CITY OF DOVER

PLANNING TECHNICAL REVIEW COMMITTEE –AGENDA

1. 10:30 AM - 11:15 AM: Site Review for Changing Places, LLC, Assessor's Map 24, Lots 98, 99, 100, zoned CBD, located at 15, 19, & 21 Mechanic Street. (Proposal is to develop a mixed use commercial/residential/flex space building with a 26,805 s.f. total building area and 24 parking spaces within the 7,267 s.f. paved area). (P17-11) [*Previously heard on February 23, 2017*]

Re: Site Plan Review
Berry Surveying & Engineering
Changing Places, LLC
15, 19, 21 Mechanic Street (Tax Map 24, Lots 98, 99, 100)

SHEET 4 OF 21

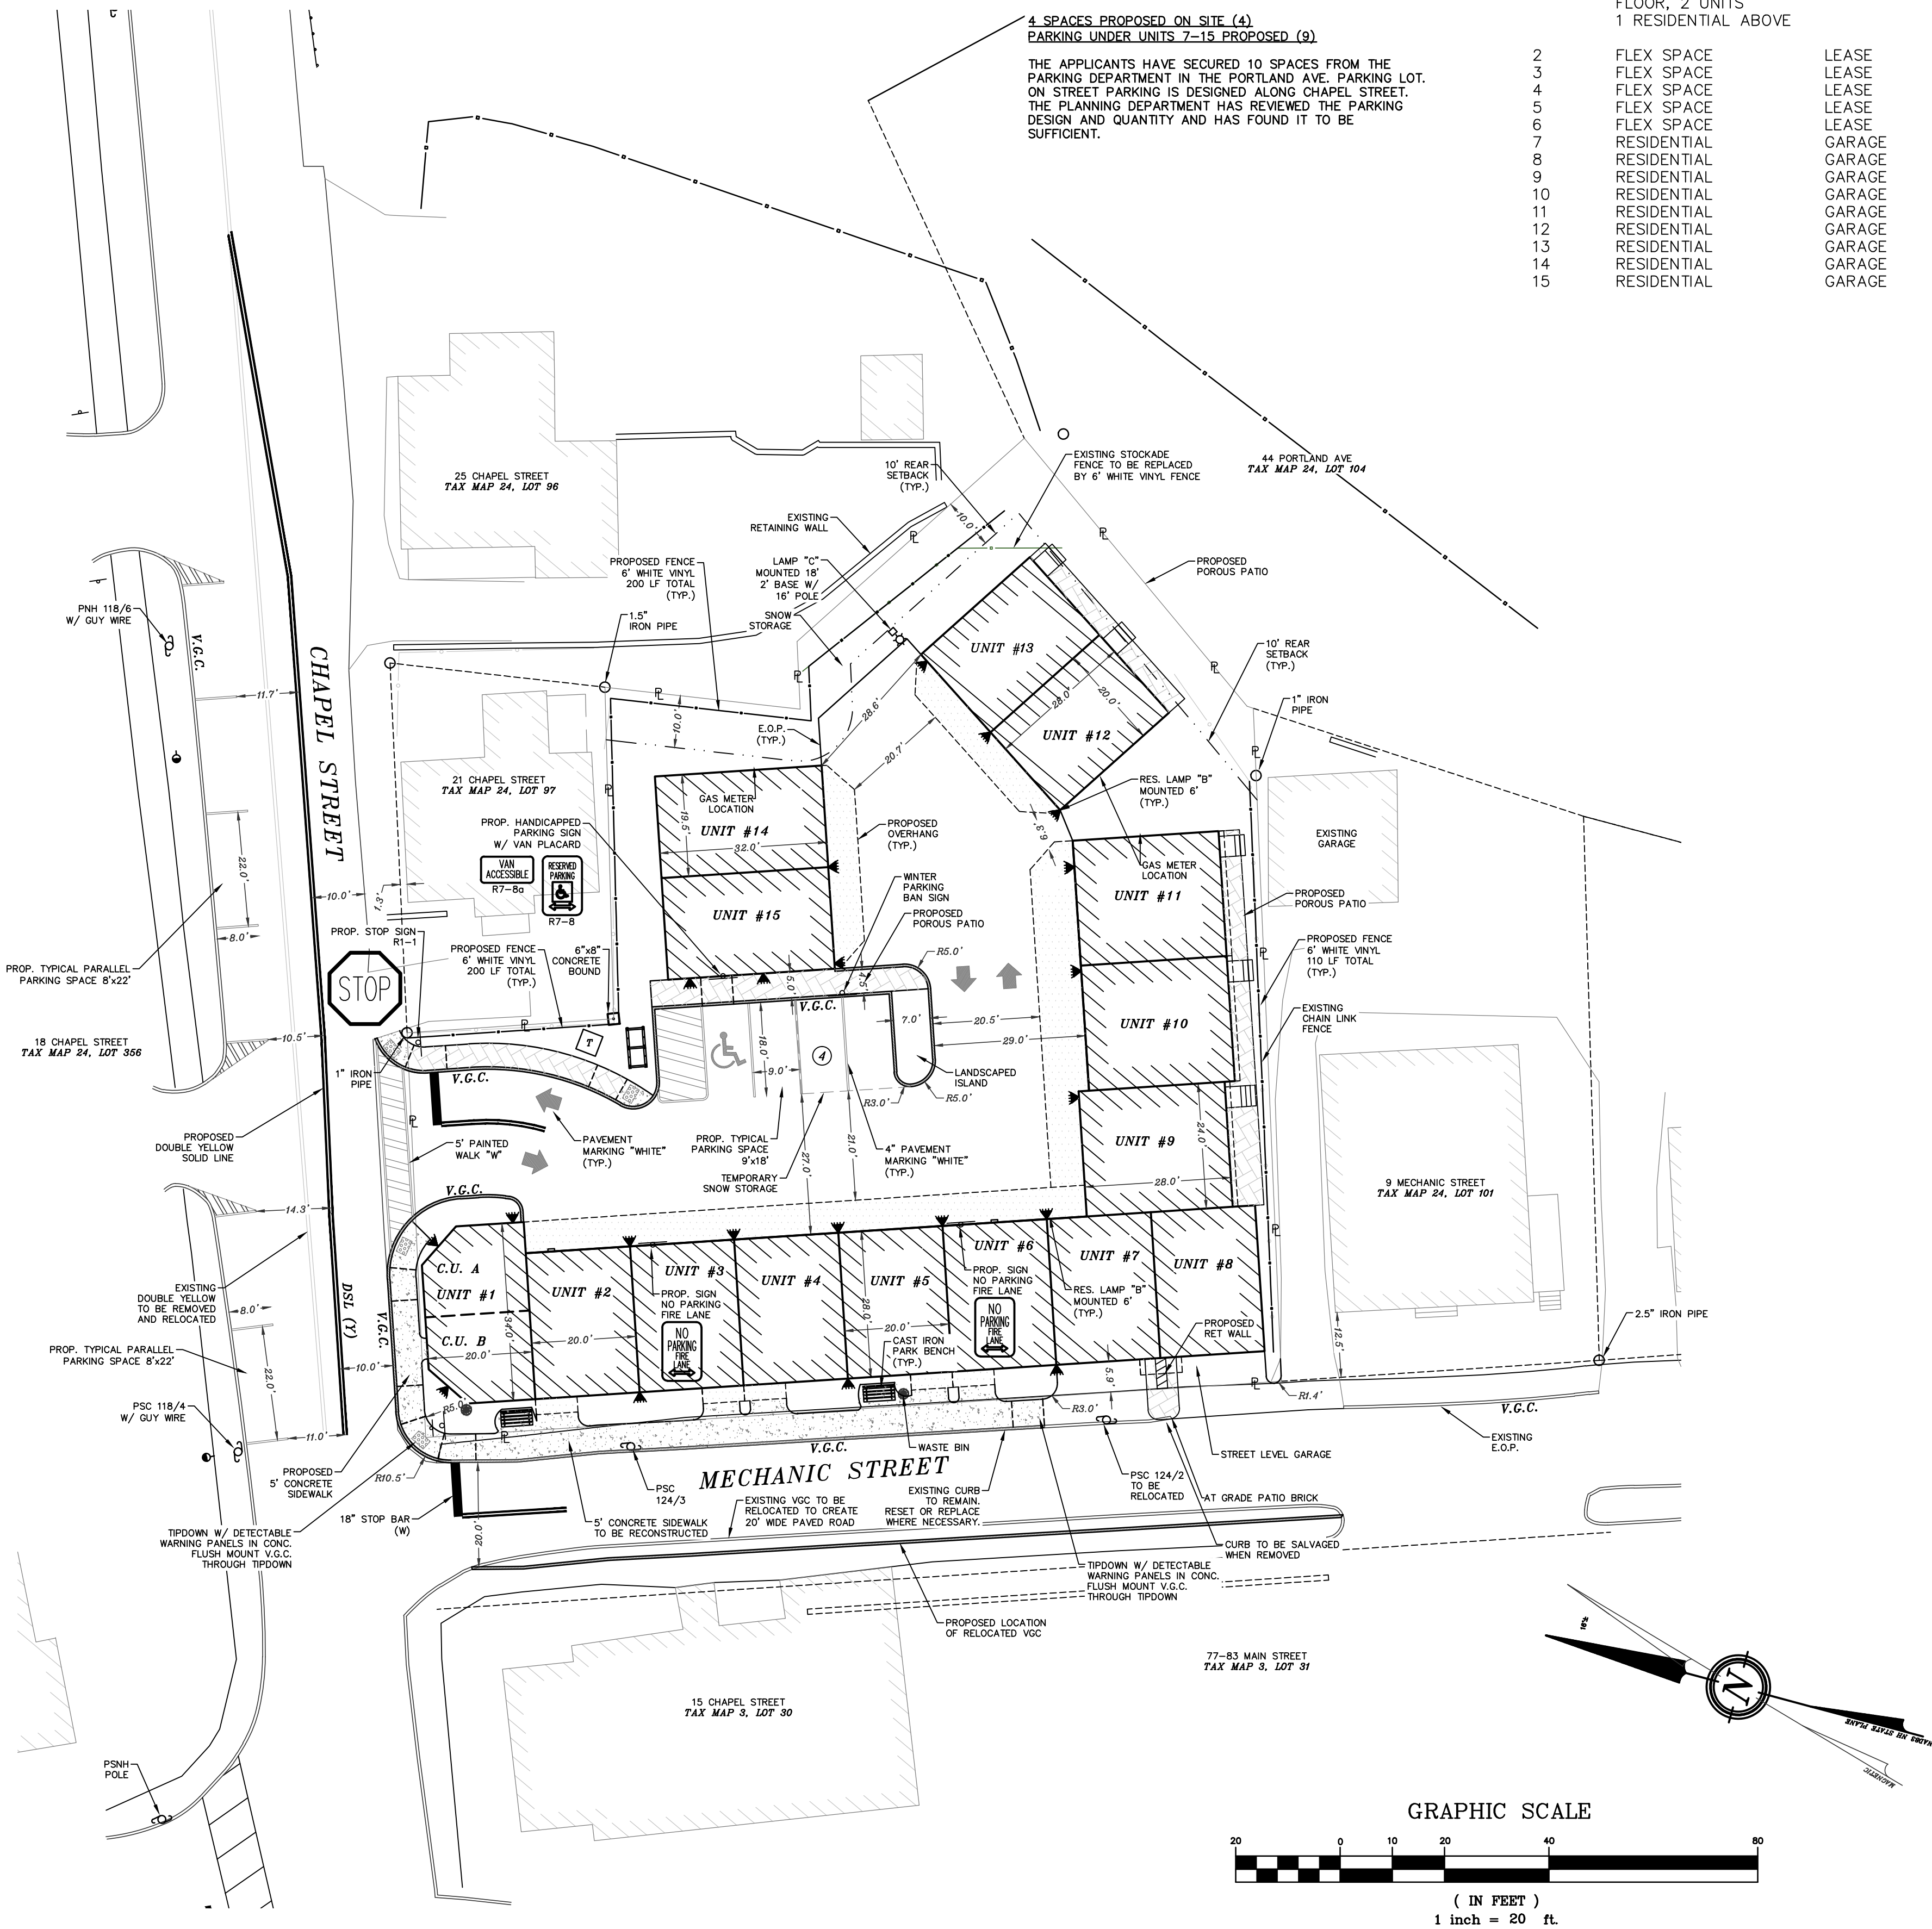
- **The file number has been added to all sheets and the cover sheet.**
- *Add stormwater recording note*
 - **Note #40 has been added to Sheet 4 of the plan set.**

- *Indicate width of egress*
 - **The entrance aisle is 24' wide and is now shown on the Sheet 4.**
- *Depict any storage or loading bays*
 - **None proposed.**

- *Add waiver note*
 - **Waivers are now listed in note #35 on Sheet 4 of the plan set.**
- *Confirm building coverage calculations – 8,935 sf conflicts with 10,812 sf footprint on application*

- **This has been updated.**
 - *Doesn't meet lot coverage*
 - **The proposal includes a CUP for lot coverage.**
- *On Sheet 4, correct note 35 regarding frontage build-out*

- **This CUP is not needed. The proposal meets the build-out requirement.**
- *On Sheet 5, note 1 describes "commercial space on the first floor and 15 residential units on the second, third, and fourth floors"*

- *Screen transformer and generator if applicable*
 - **A revised annotation is now on the Sheet 4 and the Landscaping Plan.**
- *On Sheet 19 – revise bench to make it compliant with ADA*

- **Perimeter buffering is indicated on the Landscaping Plan.**
- *Indicate totter location*
 - **Toter's are to be located internal to the unit until such time as it is collected by private pickup.**

- **The plans have been updated to reflect the 10,812 SF on the application.**
- *Add floor plans to plan set*
 - **The Floor Plans are now part of the Plan Set.**

- *On Sheet 10:*
 - *Indicate height of lights*
 - **This information is provided on the Site Plan Sheet 4.**
 - *Match symbols*
 - **Symbols have been correlated.**
